CITY OF YPSILANTI
Agenda
Historic District Commission
Tuesday, March 13, 2018 - 7:00 p.m.
Ypsilanti Freighthouse, 100 Market Place
Ypsilanti, MI 48198

HDC Work Permit Staff Review

Property address: 15 S Washington

Proposed work: Amendment to previous application for lighting and paint.

WST LED

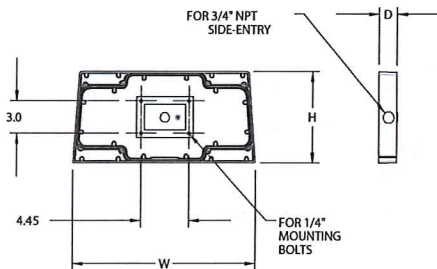
2. The applicant contacted staff the day after the HDC meeting to advise that the light that was approved for above the service doors was only available in color temperatures that were higher than what the HDC permits.

Cynthia, I guess it would have been nice to know about the lighting fact sheet prior to last night's meeting, because the fixture we proposed for the service door has color temperature options of 4000K or 5000K (i.e. over 3000K, so not appropriate per the fact sheet).

Move to approve the amended application for work at 15 S Washington to include a new Contech Lighting CYL6 6" integrated LED indoor and outdoor cylinder light in bronze finish above the service door on the east façade. Work to also include the painting of the exposed beams on the building in Sherwin Williams SW6988-Bohemian Black or similar.

CYL6

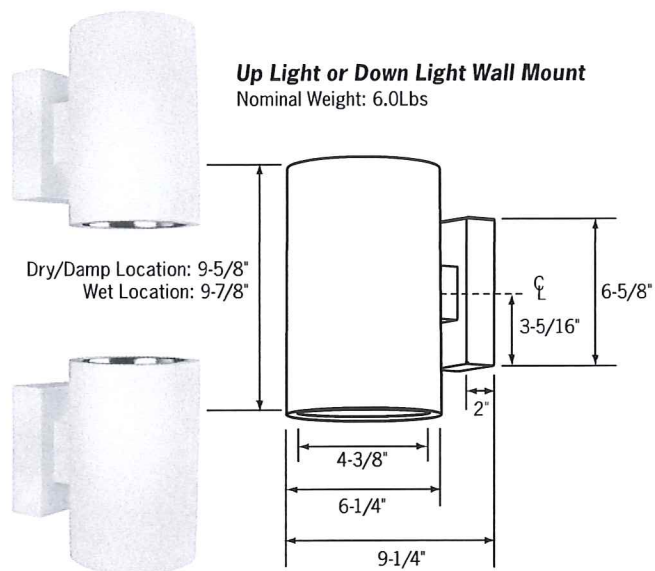
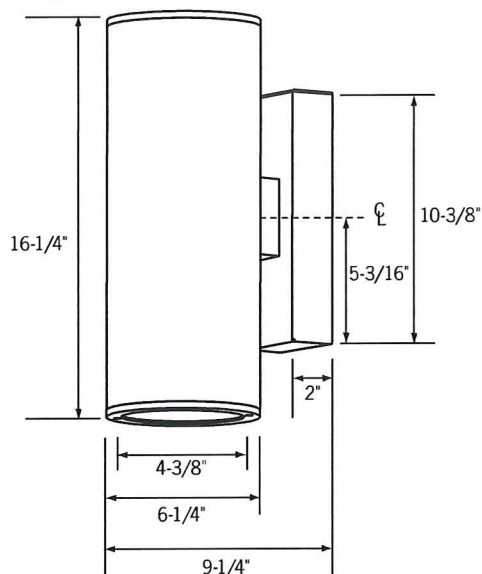
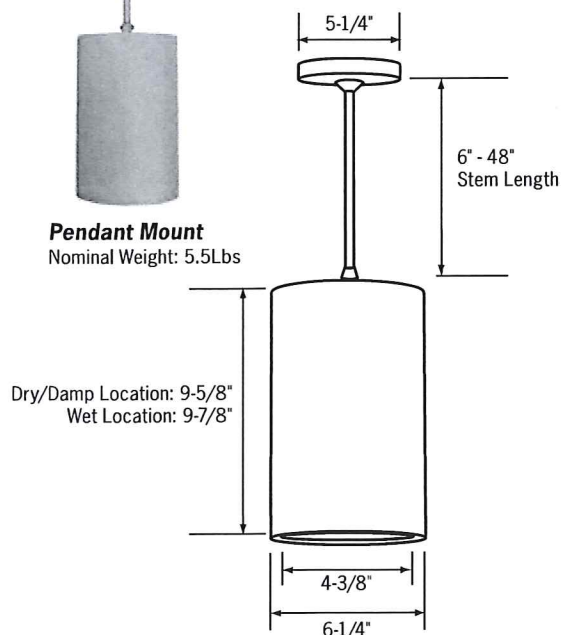
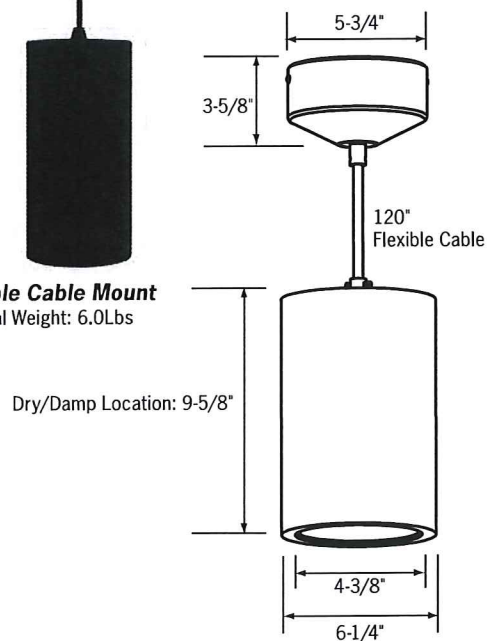
3. The applicant suggested two options via email; a new light that is available in the correct color temperature but similar to the one that was previously approved or a down directed cylinder light like the ones that were approved for under the canopies. The owner prefers the cylinder light.

Cynthia, I met with the owner today; there was a slight preference for the down-directed cylinder to match the other exterior fixtures, but not strong if the HDC feels otherwise.

SOUTH ELEVATION
SCALE: 1/4"=1'-0"

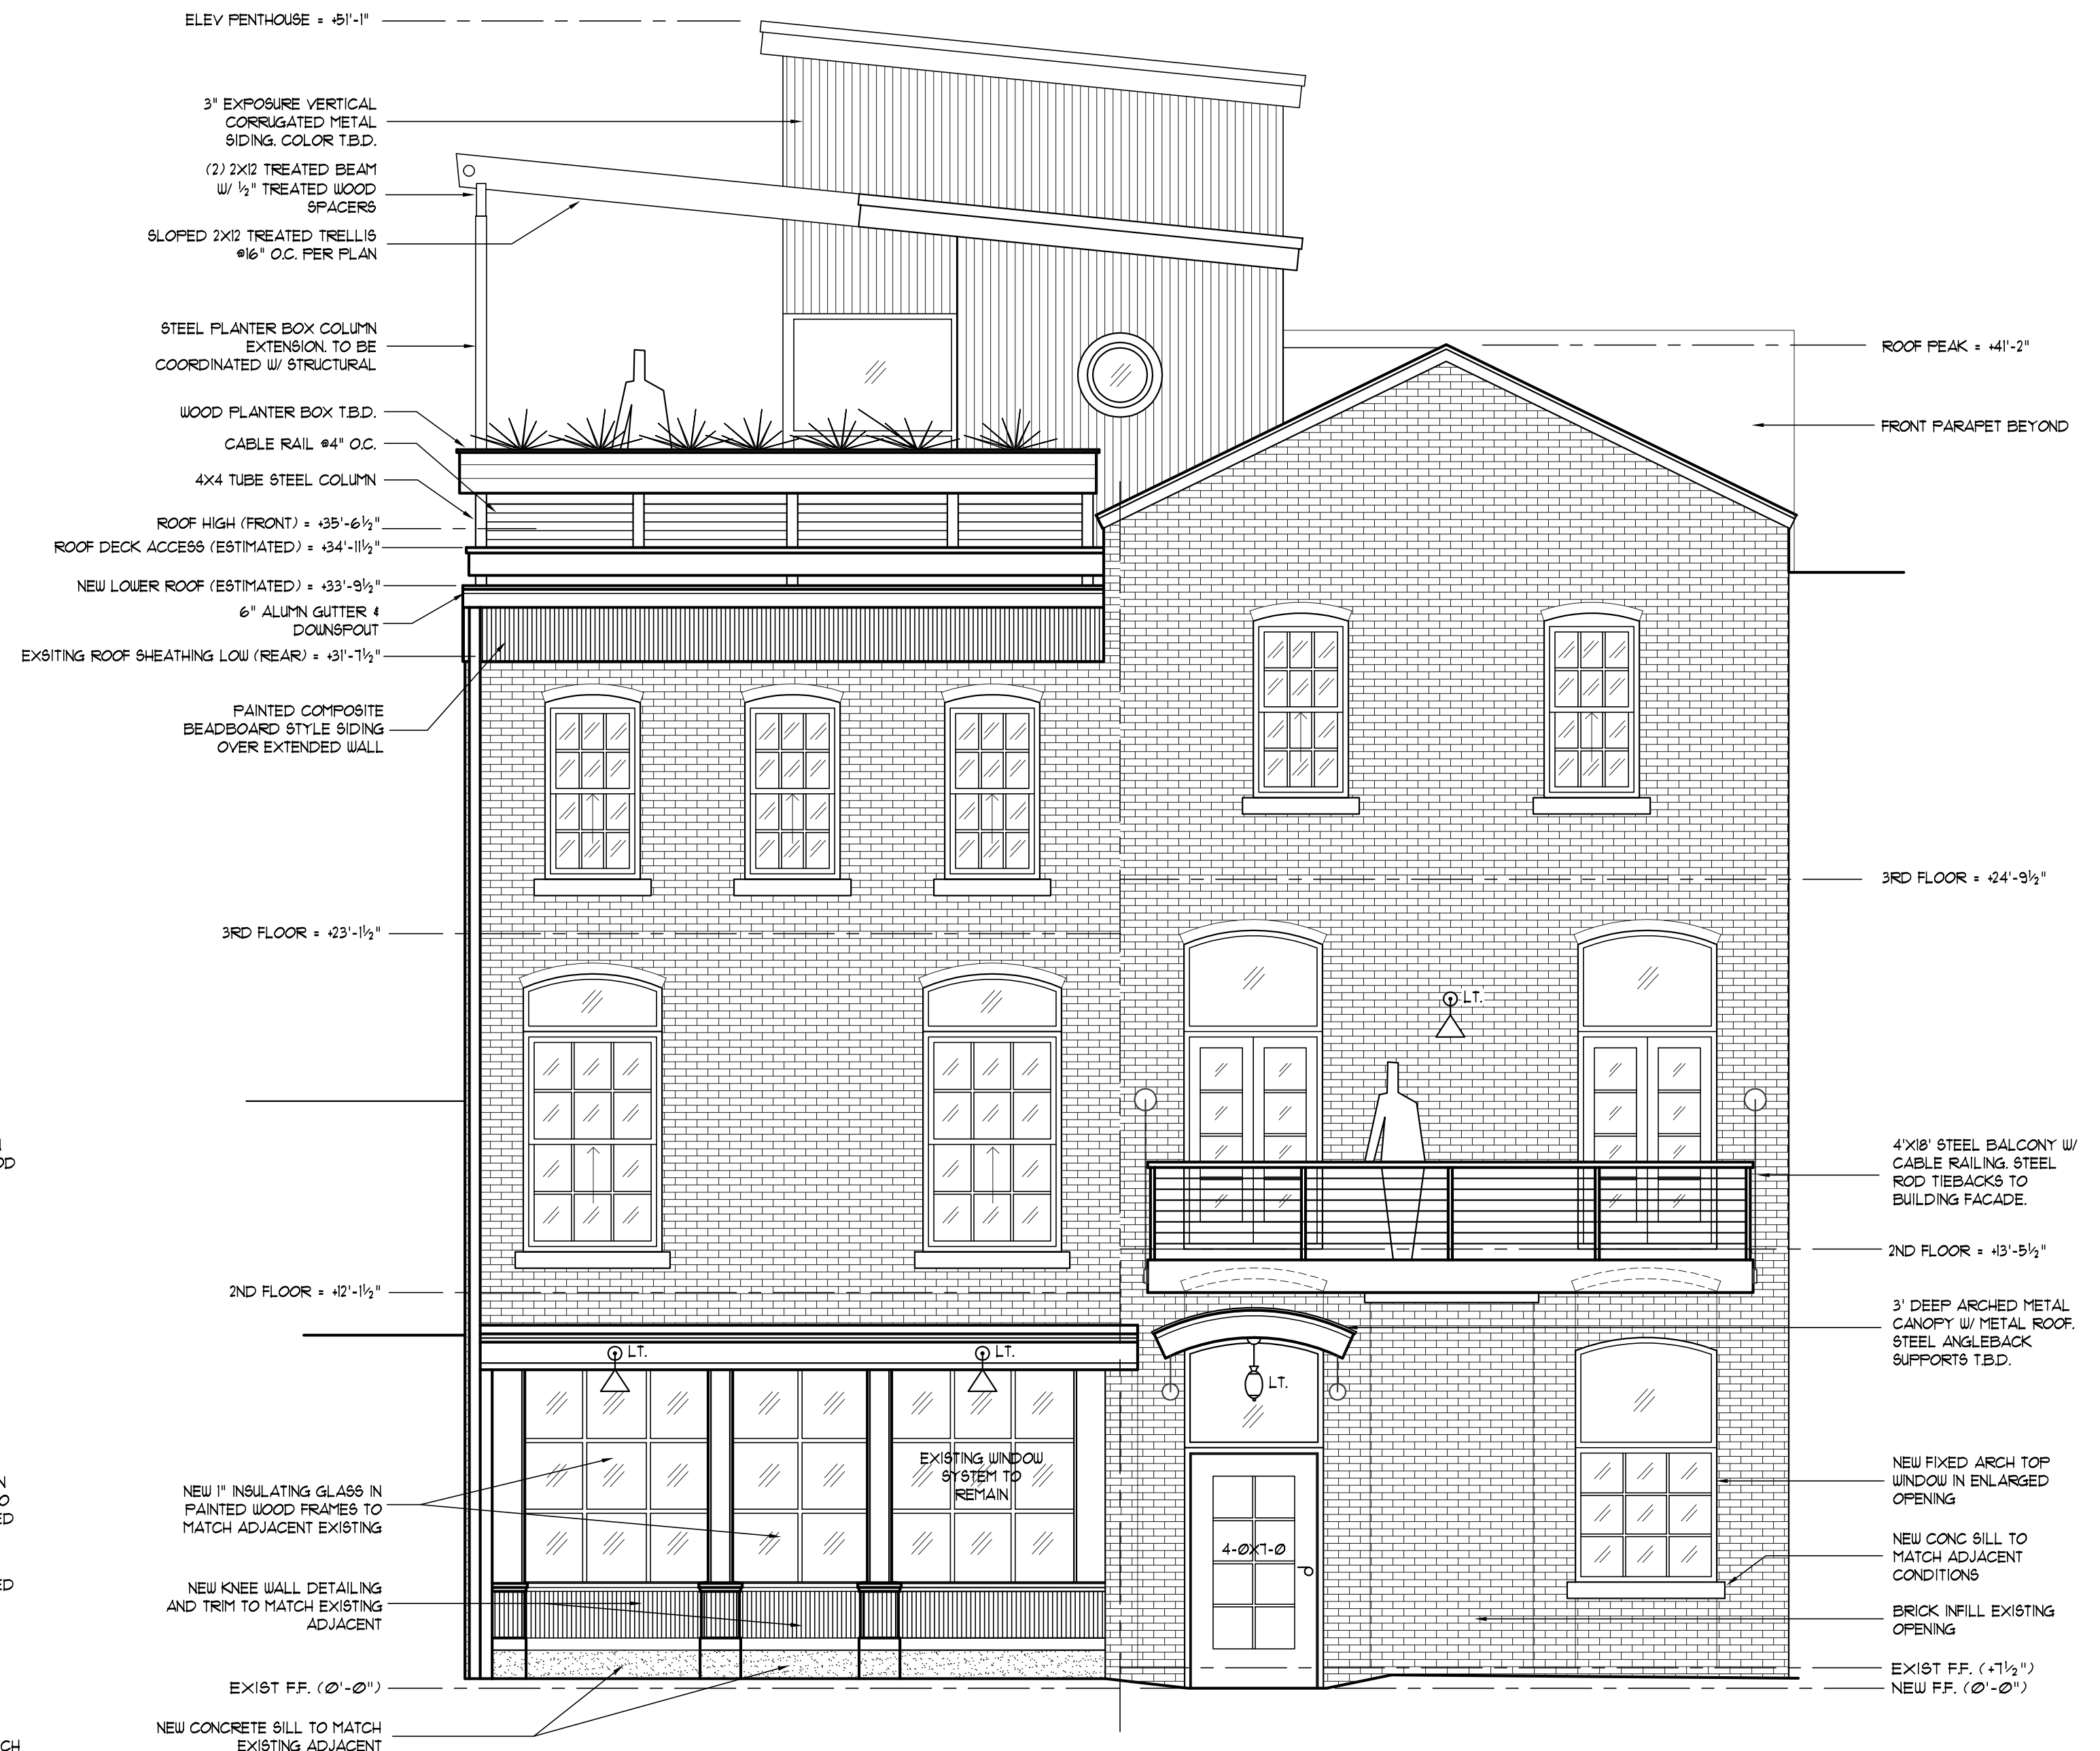
5. The application does not include any details on the windows, paint colors, signage, exterior flooring material, planter box railing nor lighting specs. Other smaller details are missing as well.

Massage Mechanics Blade Sign
February 26, 2018
Drawings are not to scale

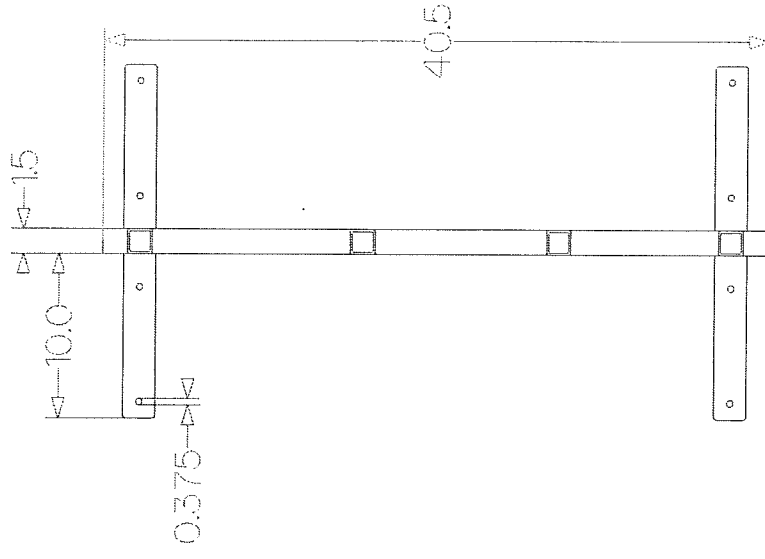
Weir: Stated they want a hanging sign for the front of the building. Added it is the same sign designer that did the sign for Hyperion Coffee. They have not thought about lighting yet because they are focused on sign and the awning may create a barrier for lighting.

Weir: Added that the sign will be made of PVC and vinyl.
